OFFICIAL COORDINATION REQUEST FOR NON-ROUTINE OPERATIONS AND MAINTENANCE

COORDINATION TITLE - 17 LMN 10 - Lower Monumental Unit 3 Blade Position

PROJECT- Lower Monumental Dam

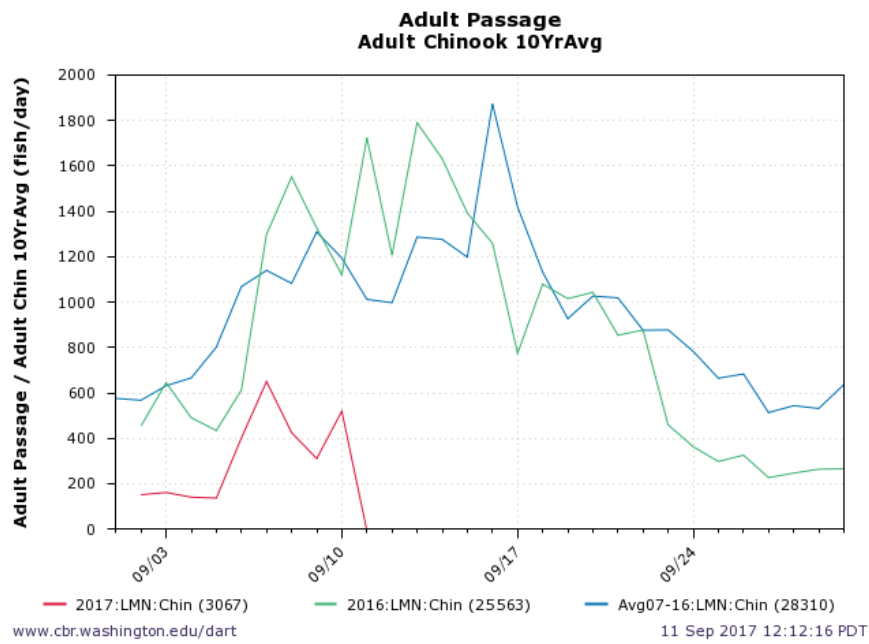
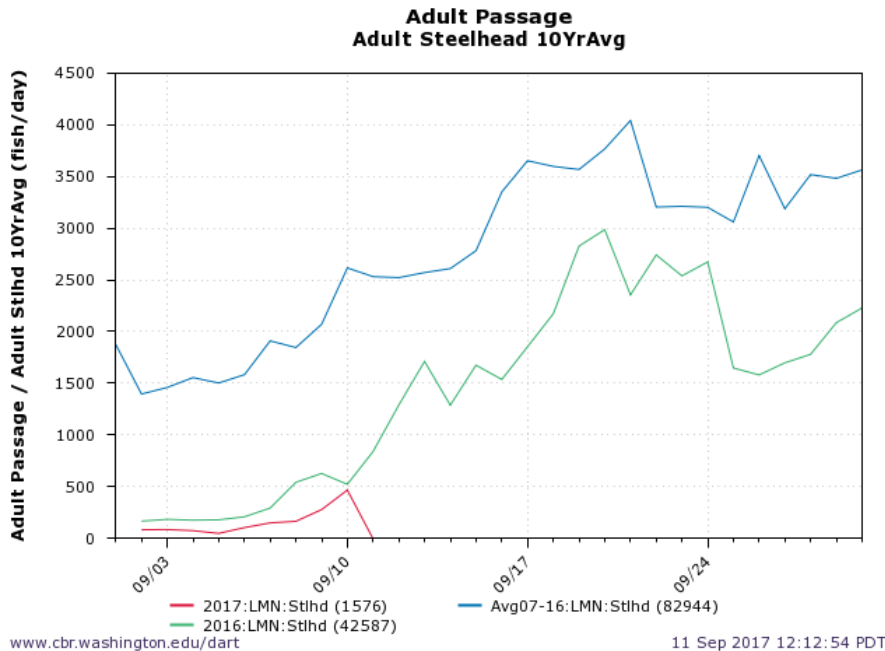
I will be supportive of fixed angle that meets 10.8 kcfs minimum 1% generation ops described in the 2017 FOP. Given past results and operational constraints that build in a volume increase above FOP documents stated performance, fixing the blade any higher will simply erode powerhouse passage. If a summary of what blade angles correspond with turbine flow kcfs that will be helpful. Thanks.

As we discussed on the phone, NOAA supports the proposed angle as long as it fall within the 1% efficiency range. Another factor to consider

would be how the different screens at LWG and LMN would affect the efficiency prediction. After two missed attempts by HDC to hit the 1% target at LWG, we suggest an angle at LMN that is highly likely to fall within 1% so we don't have to do this a second time. Please inform us as soon as the testing confirms if we are within the 1% range or not.

LMN Unit 3 Fixed Blade Angle (Hockersmith, Setter) – The project fixed the blades at 28.5° which is below the upper threshold of 1 %. The unit came back to service on 12 September. Unit 4 returned to service on 13 September. Units 3, 4 and 6 are now back in service. Unit 3 commissioning testing will be the second week of October. The project will conduct index testing to verify that it is within the 1% band. The blade angle can be adjusted after the testing if necessary. Hockersmith will update FPOM with the testing results.
